MEMORANDUM

From: Service Manager Environment **To:** Head of Environment and Planning
Our Ref: EP/DC/PP/2016/1048 **Your Ref:** PF/P/2016/1048
Date: 22nd November 2016

Location: O. S Grid Ref: 352 520 The Goulbourne, Borrass Park Road, Wrexham.

Development: Residential development (9 no. detached dwellings) and construction / alteration to vehicular and pedestrian access.

Turning Areas

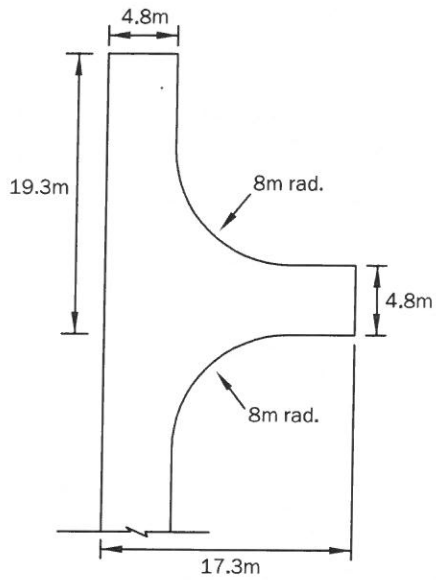
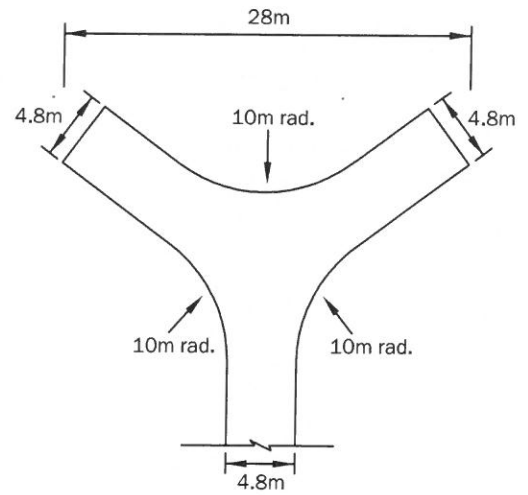
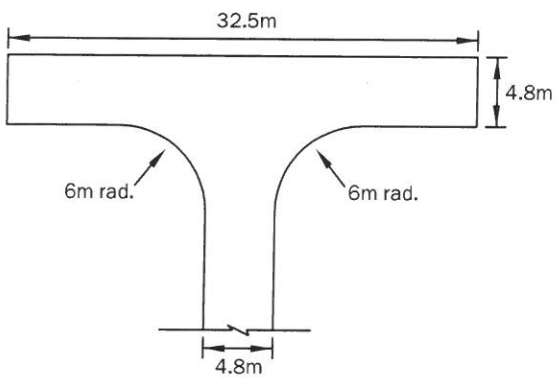
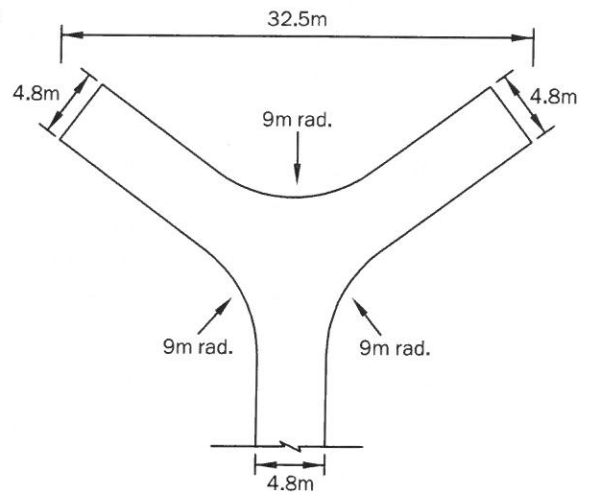
The proposed layout / horizontal alignment of the estate road appears unusual with an awkward sharp bend. Such a layout would make it difficult for refuse vehicles / larger vehicles to negotiate through the site particularly if on-street parking occurs and would result in vehicles encroaching onto the opposite side of the road which is not ideal. I would recommend that swept path analysis details are submitted to determine whether any localised road widening is required. **Details indicating the movements of an 11.2m long refuse vehicle shall be submitted (entering / turning / exiting the site).**

The proposed turning head is of insufficient size and does not comply with WCBC adoptable standards. **I would recommend that the applicant provides a revised layout plan indicating a turning head complying with adoptable standards (see attached detail).**

Turning areas are based on an 11.18m long, 2.55m wide refuse vehicle.

PARKING AND DRIVEWAY ARRANGEMENTS

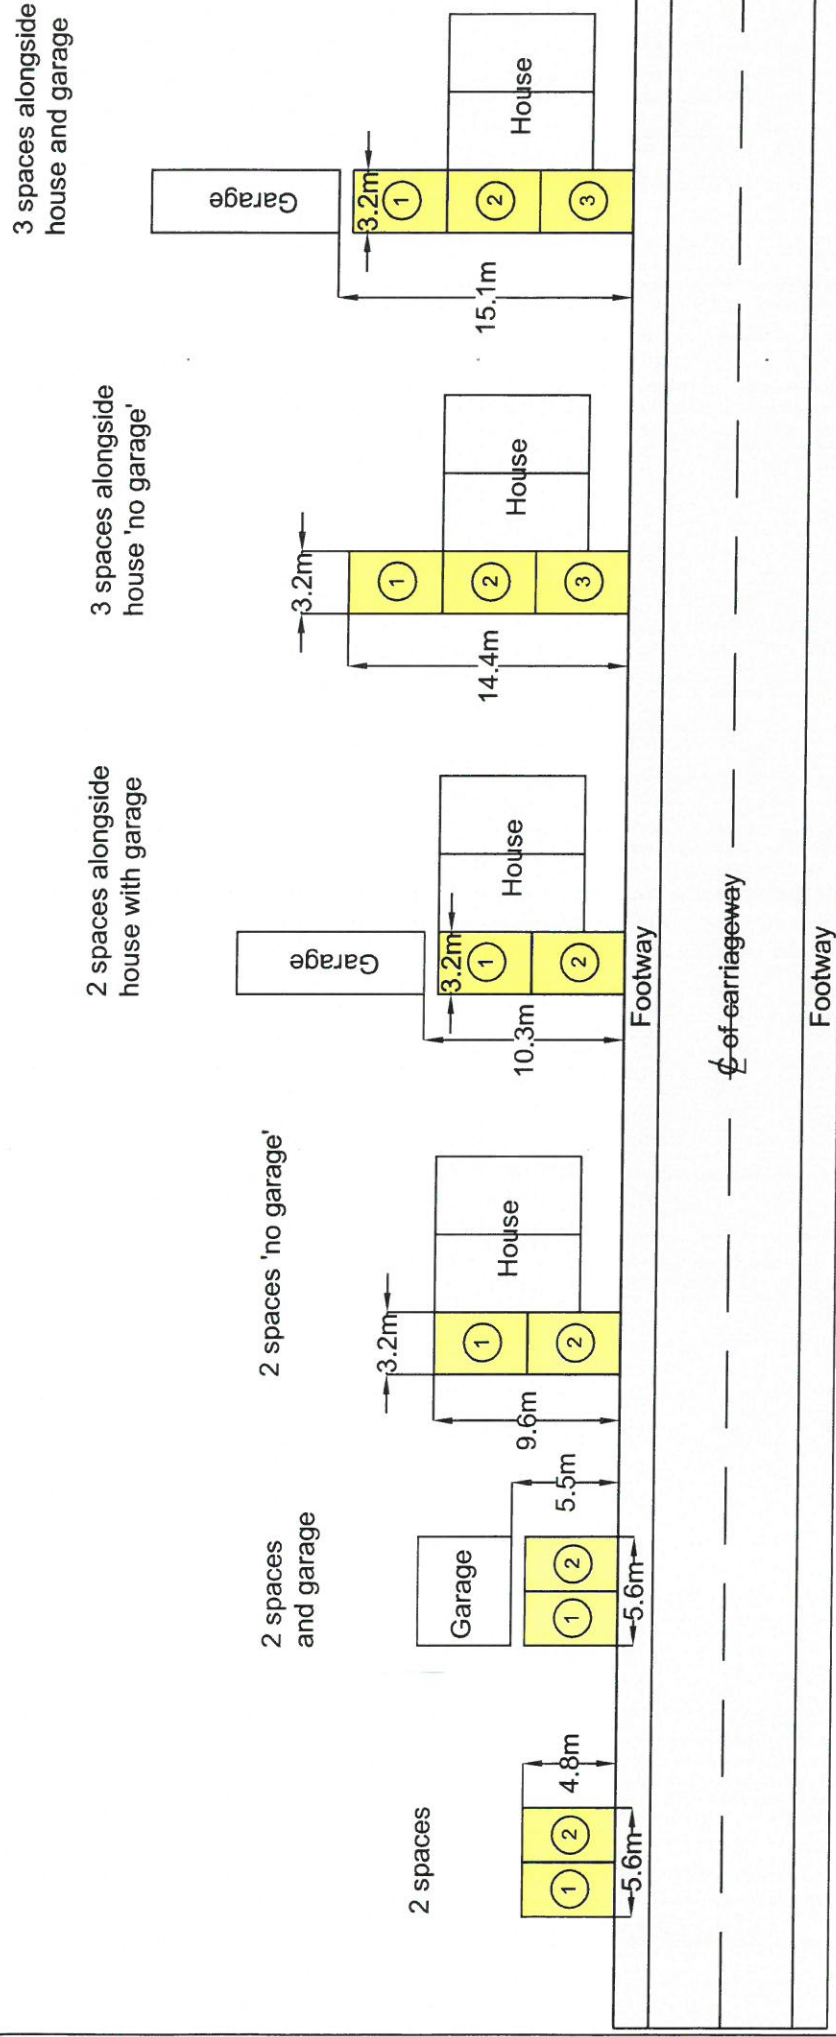
A number of the proposed driveways are of inadequate width / length and do not comply with our current standards (see attached details). **I would recommend that the applicant submits a revised layout plan indicating / annotating the required driveway dimensions for each plot.**

revisions	title	scale	date
	ACCESSWAY RAMP	1/10	1/95
		drawing no	11/01/06
		sheet	1 of 1

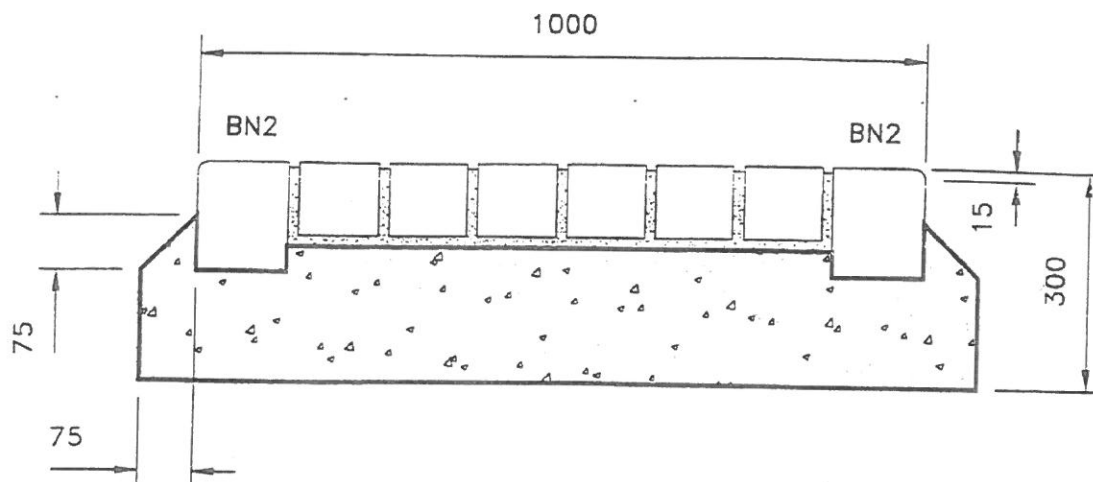
As the proposed estate road takes the form of a shared surface, an accessway ramp will be required at the main access (see attached detail). This has not been shown on the submitted layout plan. **I would recommend that the applicant submits a revised layout plan indicating this detail.**
